## Riley Purgatory Bluff Creek Watershed District Permit Application Review

**Permit No:** 2023-003

**Project:** Galpin Boulevard Reconstruction - The applicant proposes to reconstruct Galpin Boulevard (CR 117) from Highway 5 in the south to the City border with Shorewood to the north. The applicant also proposes to replace the Bluff Creek crossing under Galpin Boulevard. The applicant proposes to provide water quality treatment, volume abstraction and rate control for runoff prior to discharging offsite using five existing stormwater facilities, enhancing two additional existing stormwater facilities, constructing three new biofiltration basins, and constructing a wet pond.

**Reviewer:** Scott Sobiech, P.E., Barr Engineering Co.

SHEET  
**34R**  
 OF  
**286**  
 SHEETS

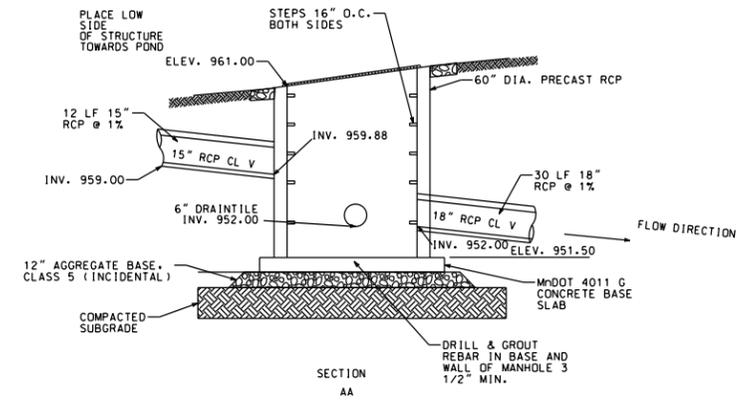
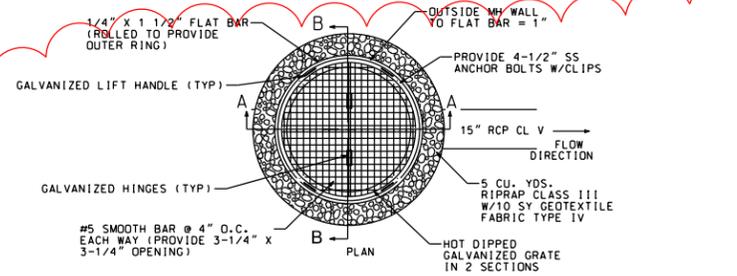
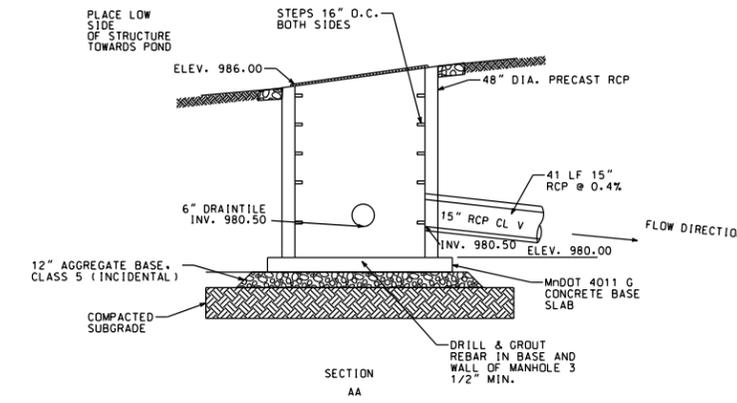
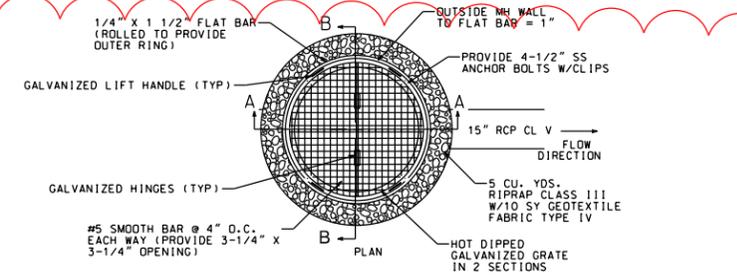
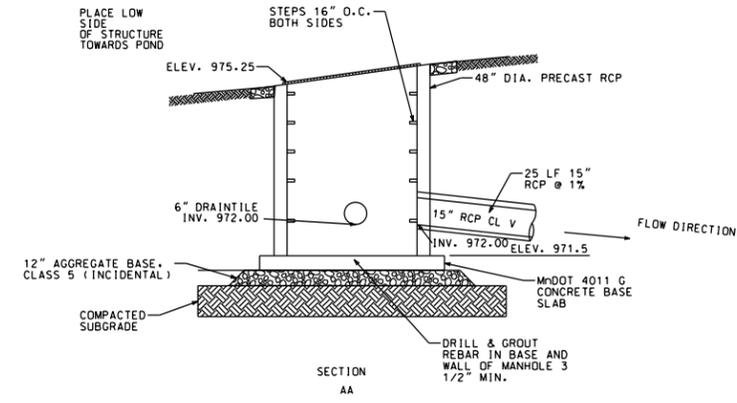
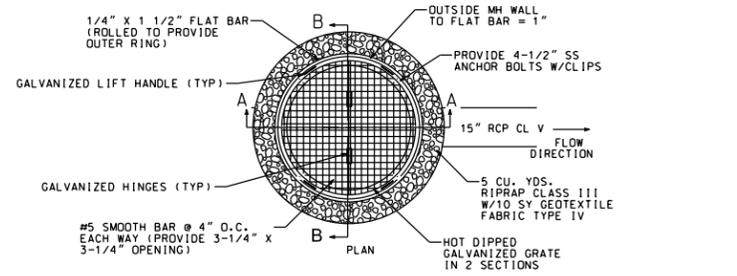
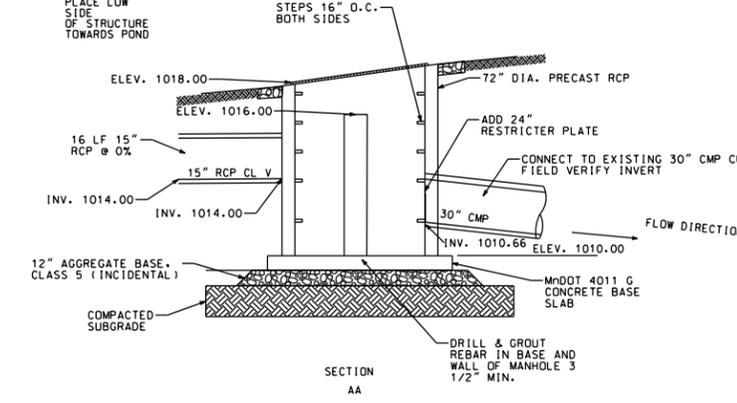
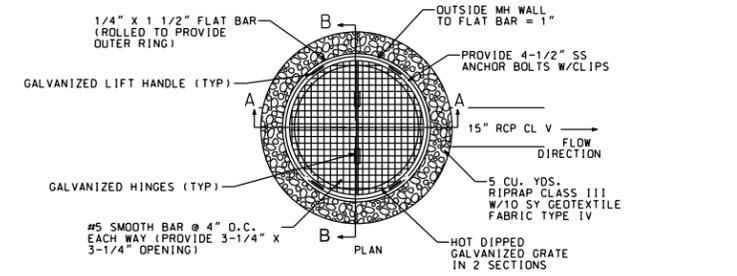
Criteria 3.3 is met because, as shown on Plan Sheet 34R, the proposed flared end sections will include a riprap apron and stilling basin to reduce risk of bank erosion (criteria 3.3a). Because there are upgradient stormwater features which will reduce peak flows and reduce pollutants, the project conforms with criteria 3.3b and 3.3c.

SHEET 216R OF 286 SHEETS

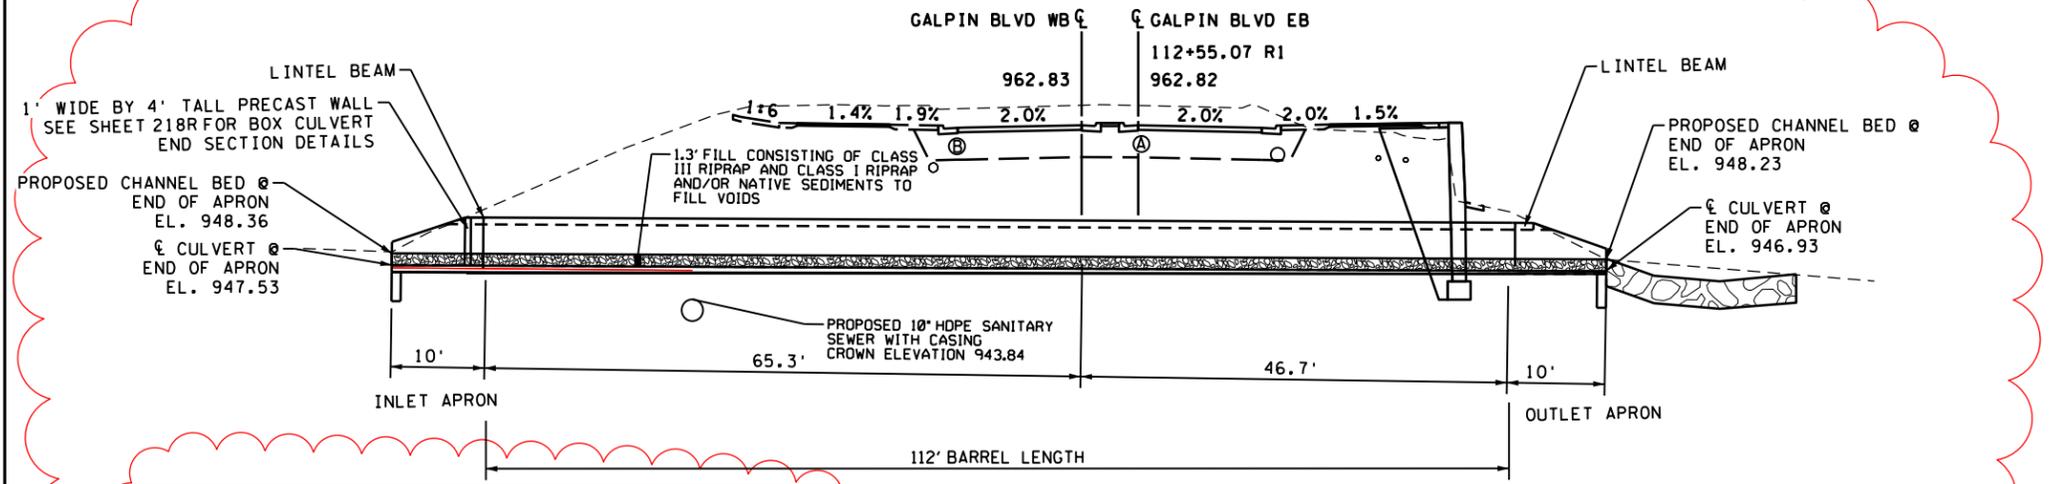
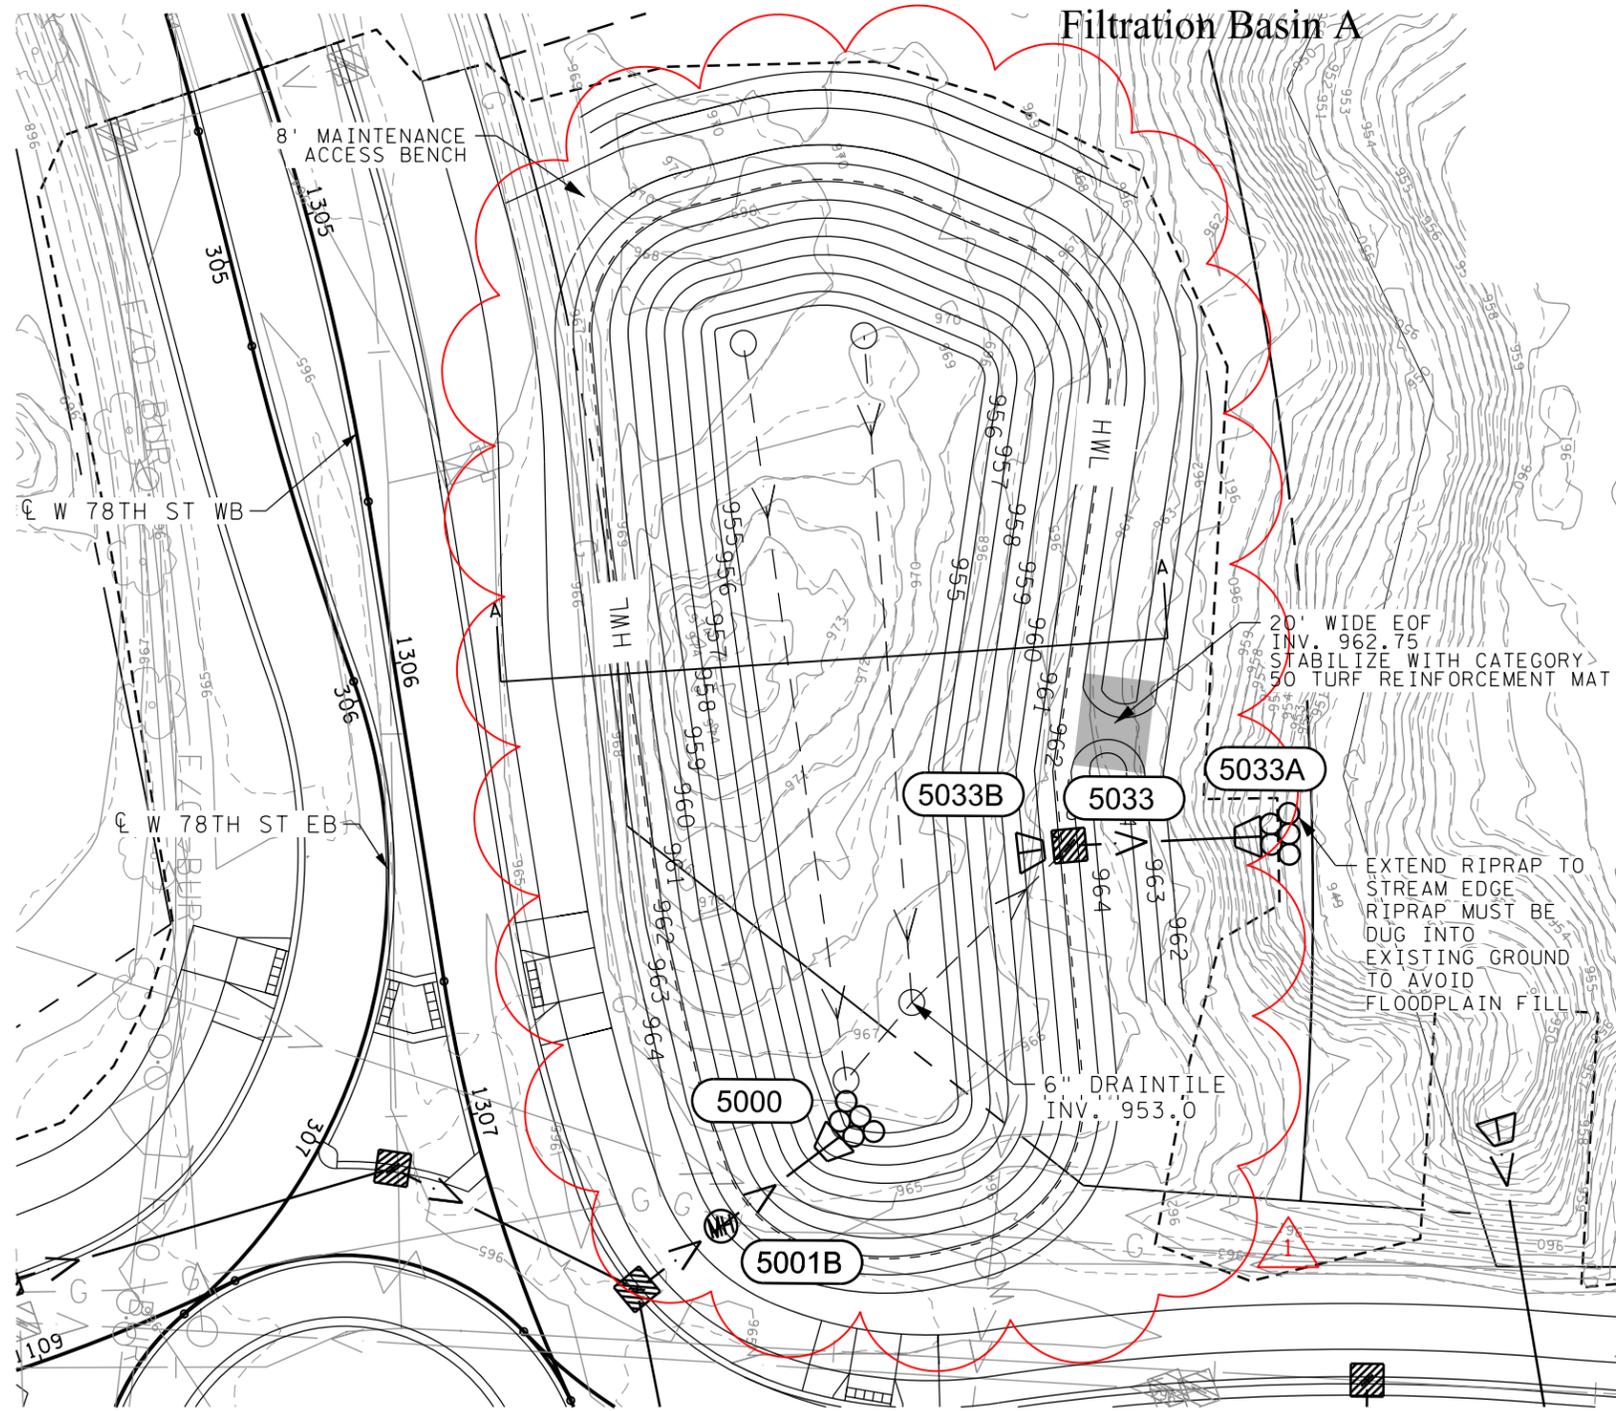
The applicant proposes to replace the existing 42-inch culvert conveying Bluff Creek flows under Galpin Boulevard with a 6-foot wide, 4-foot high box culvert with a 1-foot restriction sidewall to reduce the controlling flow width to 5 feet. This work will provide a public benefit by allowing the creek to cross in a properly bedded and stabilized box culvert with a much lower risk of failure. Additionally, the public water will see reduced bank erosion at the upstream and downstream ends of the culvert (Rule G, Subsection 3.1a).
